**RE: STATE SIGNIFICANT DEVELOPMENT APPLICATION 14_6724
60-78 REGENT STREET, REDFERN**

This submission is written on behalf of Phil and Tyson Donnelly, the owners of Unit 506, 157 Redfern Street, Redfern (the **adjoining property owner**) and is in respect of the proposed mixed use and student accommodation redevelopment (SSD 14_6724) at 60-78 Regent Street, Redfern (the **site**).

Figure 4 – Existing view outlook location #3 and superimposed future built form

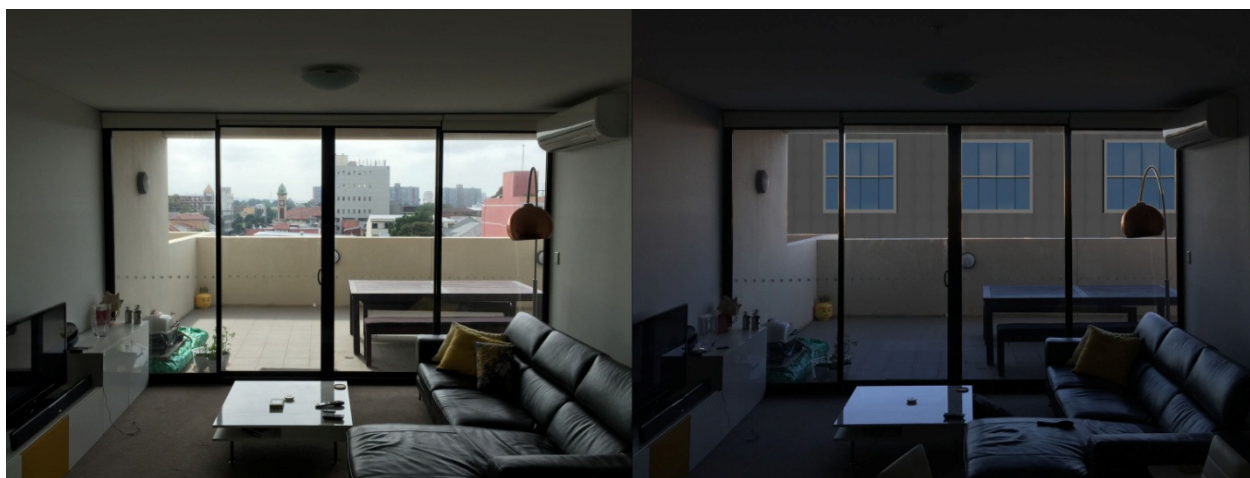
Notwithstanding the above, limited separation (12 metres in some cases) is provided between properties (to the terrace at Unit 506 from the window of Apartment 6 at proposed Level 6). However and despite privacy being a desirable element for residential amenity, the proposed 18 storey built form will undoubtedly result in a loss of residential amenity to the adjoining property owner. Not only does the built form reduce existing panoramic views and vistas (see Section 3.2 above), it will also result in material aural and privacy impacts. The proposed western elevation contains 14 windows at each level some of which are provided with a direct line of sight to the primary living room and principal area of private open space at Unit 506. This unquestionable loss of aural and visual privacy is directly attributable to the non-complying elements (height and setbacks) of the proposed built form.

Figures 2 to 5 provide a comparison of the existing outlook and visual privacy (from the terrace and open plan primary living room) from Unit 506 as compared to that with the future built form.
